Title: Advisory Committee on Reactor Safeguards
513th Meeting

Date: Thursday, June 3, 2004

NRC staff response to March 17, 2004 ACRS report on the AP1000 design;

Proposed revisions to standard review plan, Section 5.2.3, 5.3.1, 5.3.3, regarding reactor vessel materials and reactor vessel integrity and process and schedule for revising various SRP sections;

Figure 1: Uncertainty bands of aerosol removal rates (λ s)

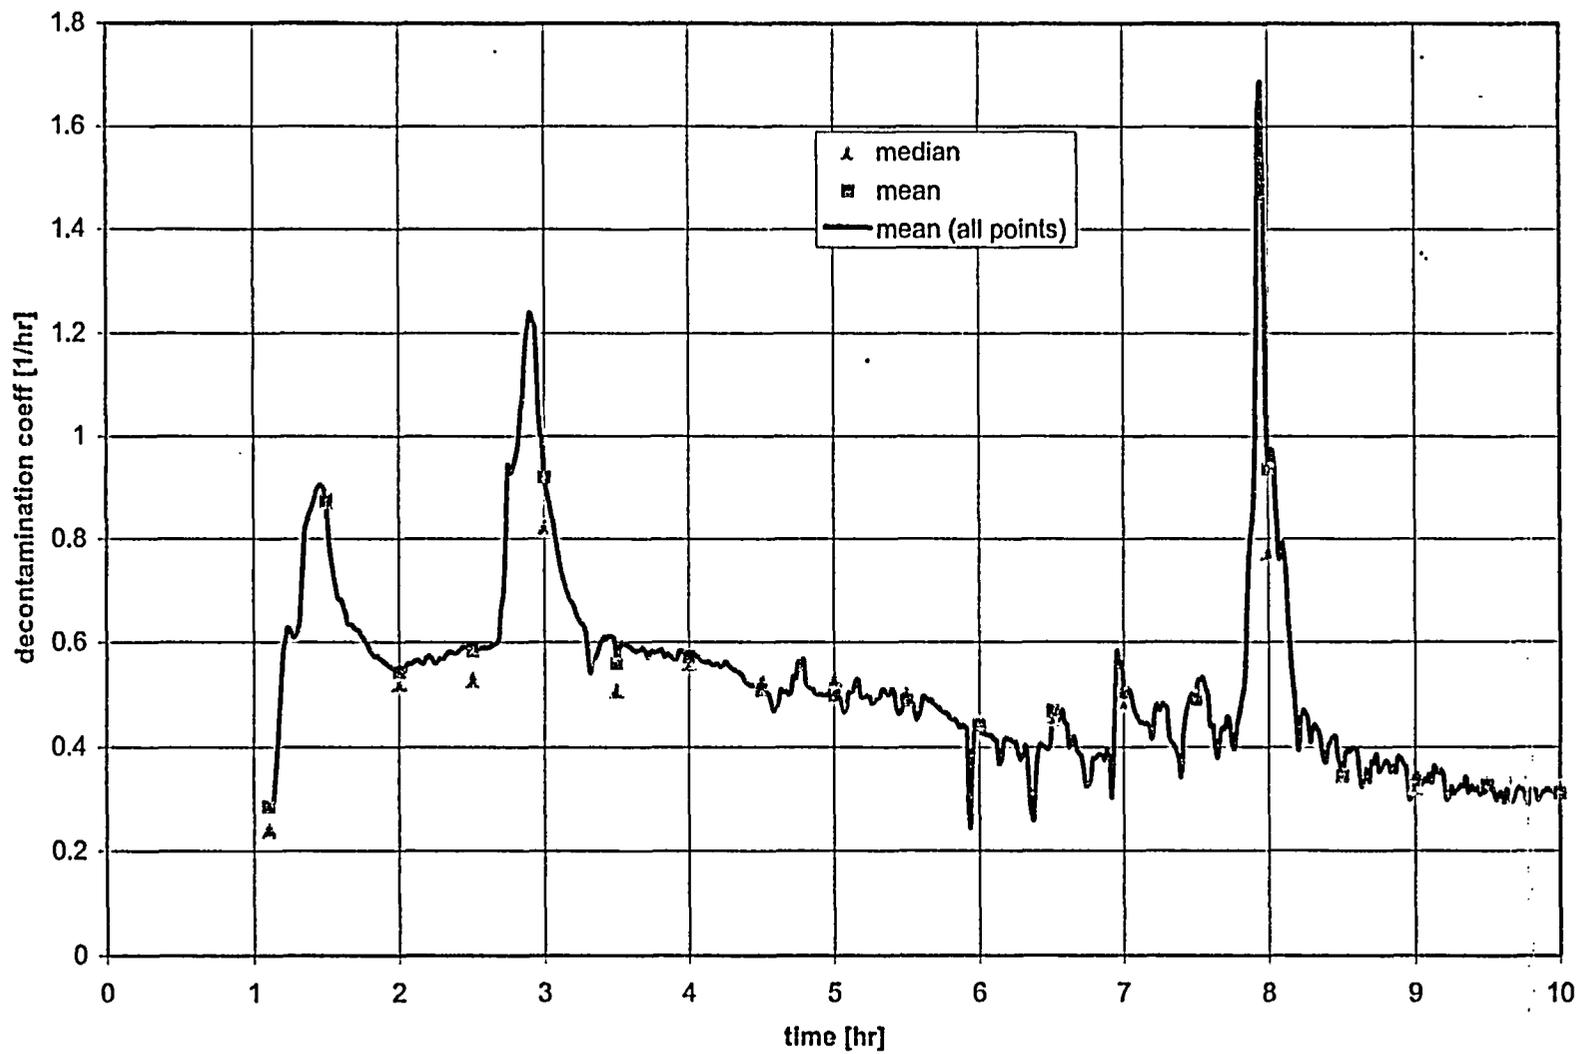
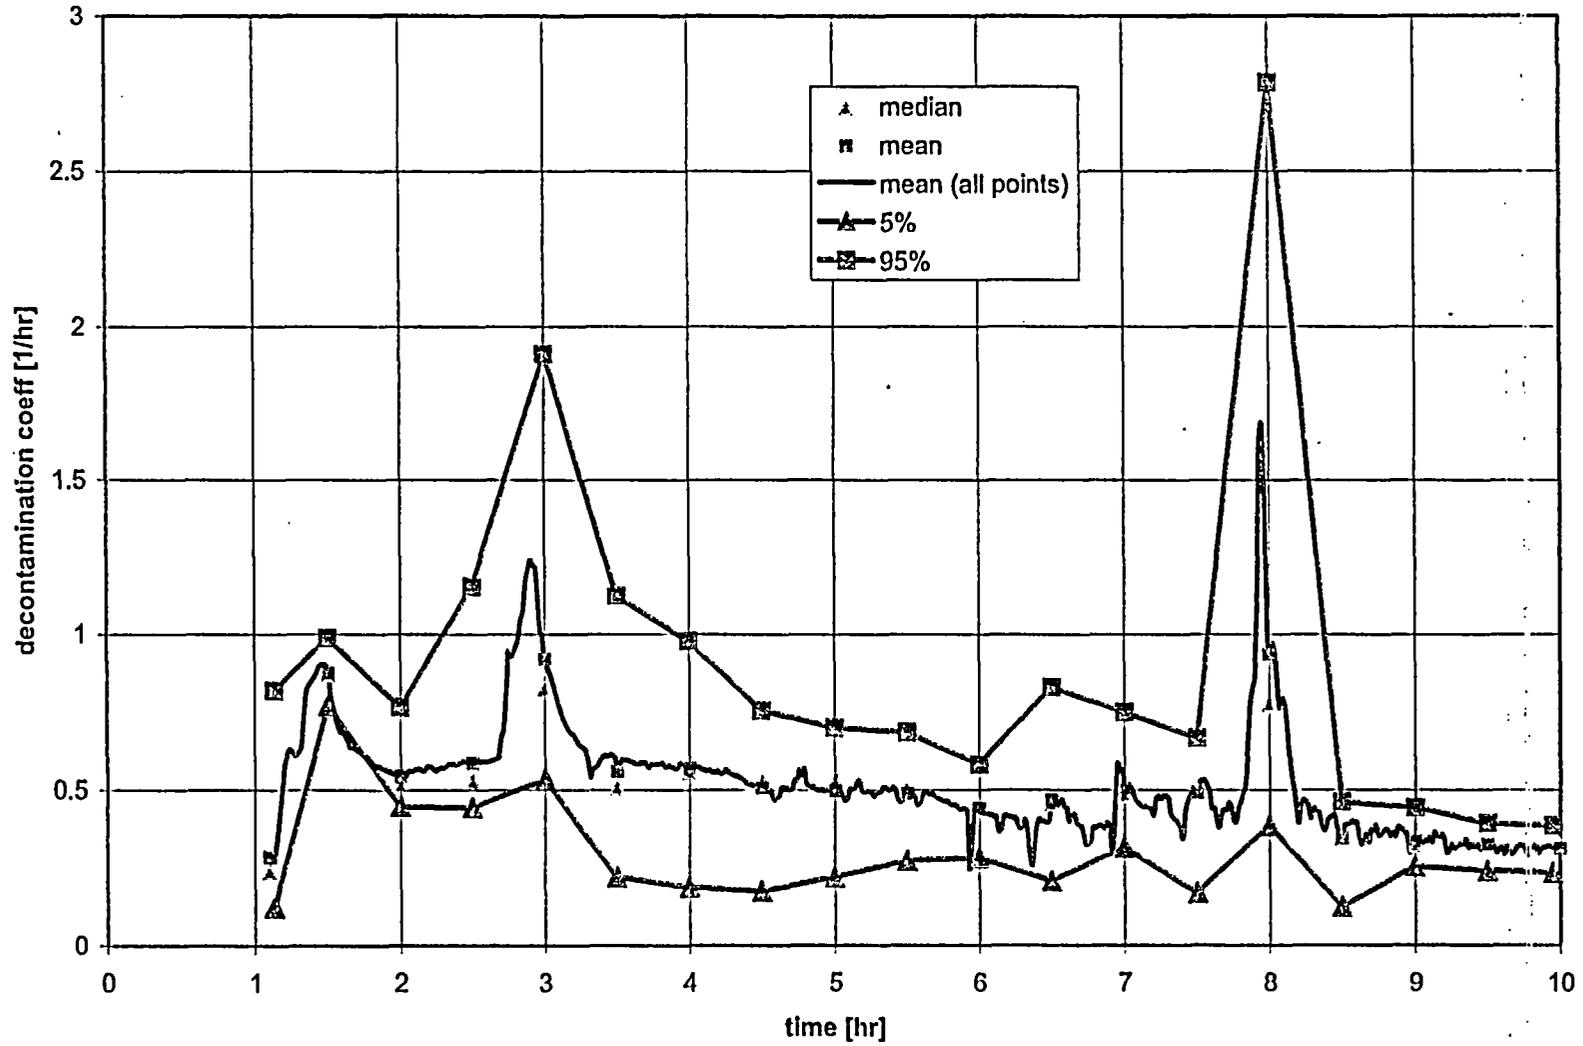
13 DR. WALLIS: Can I ask you something about
14 these curves? Now, you show 95 percentile here.
15 These aren't individual runs. At each particular time
16 you are calculating a percentile from the results of
17 a set of runs?

2 MR. DROST: Of 200 runs. That's correct.

4 MR. DROST: At a given time. That is
5 correct.

Issue 6: Organic Iodine Production

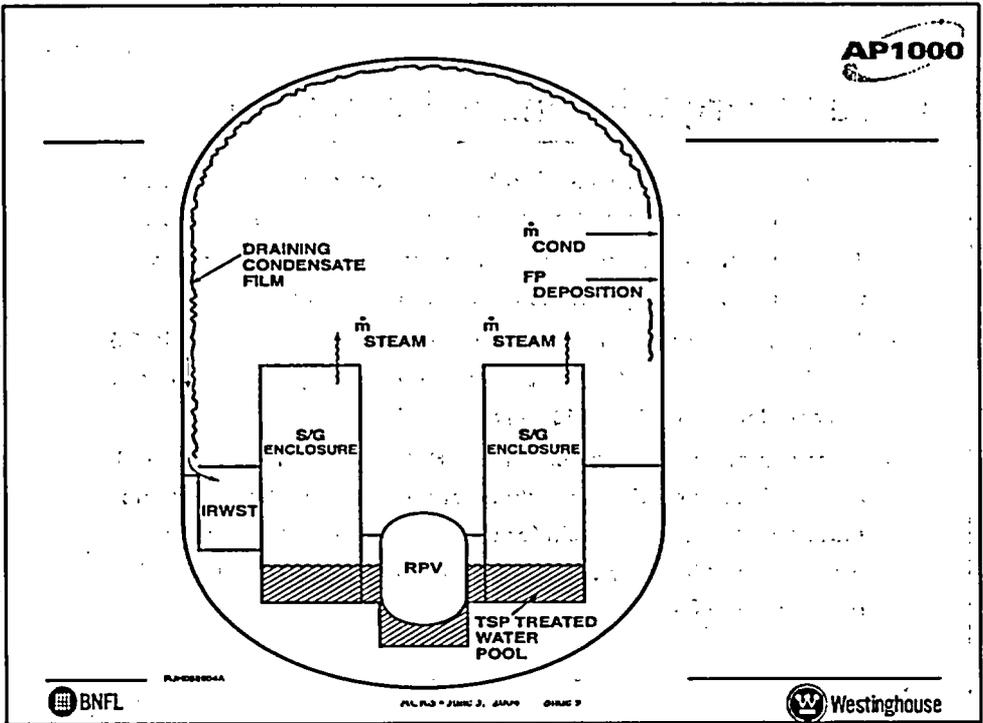
Organic Iodine Production: The acidification of containment water as a result of radiolysis of organic material could give rise to significant airborne fission product iodine in gaseous organic form. We need to review how Westinghouse and the staff have dealt with this potential.

- Formation of organic iodine as a result of radiolysis of organic materials involves the availability of elemental iodine (I_2).
- Elemental iodine can be produced from iodide (I^-) in water pools or films where pH is not controlled to be 7 or greater.

- AP1000 containment design includes TSP to control the pH of the water pool that collects in the lower compartment and reactor cavity following an accident.
